Prudence of the St. Joseph

DIRECT TESTIMONY

TED L. BIDDY

MISSOURI-AMERICAN WATER COMPANY

1993 FLOOD LEVEL INSIDE FILTER BUILDING

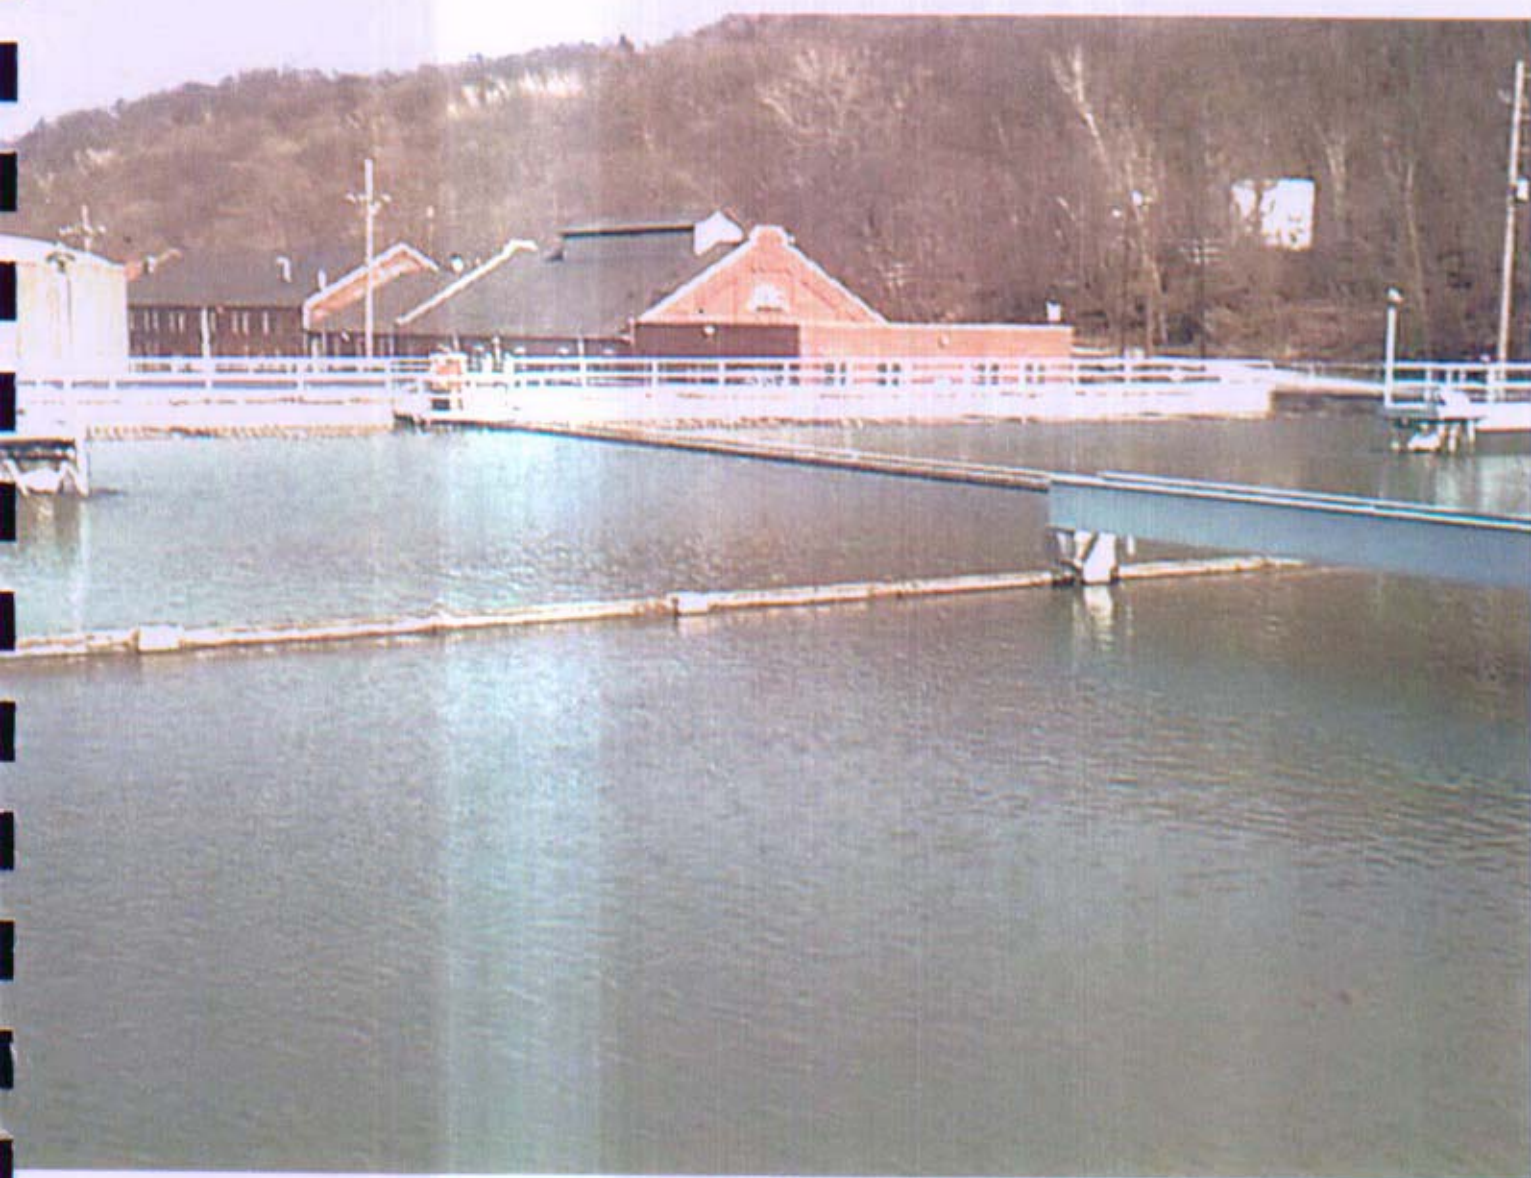
7 The 1993 flood which was rated as a 500-year frequency flood did not overtop the
8 protecting levee located on the south, west and north sides of the plant site. Rather, the
9 flood waters accumulated at the north side of the northern levee and then ran through the
10 ballast (supporting rocks below rail and cross ties) of the railroad on the adjacent east side
11 of the plant site with a "french drain" action and flooded the site from the east side. This
12 explanation of the flooding mechanism was given to me by Mr. Amman during my
13 inspection of the existing facilities.

14 Based on my observation of the east side of the plant, flood-proofing of the entire plant site
15 could easily be accomplished by either extending the existing levee from the north end
16 along the entire east side of the facility and connecting the new east side levee to the south
17 side levee, or by constructing a short waterproof cutoff wall from the east end of the
18 northern levee through the railroad to high ground east of the railroad.
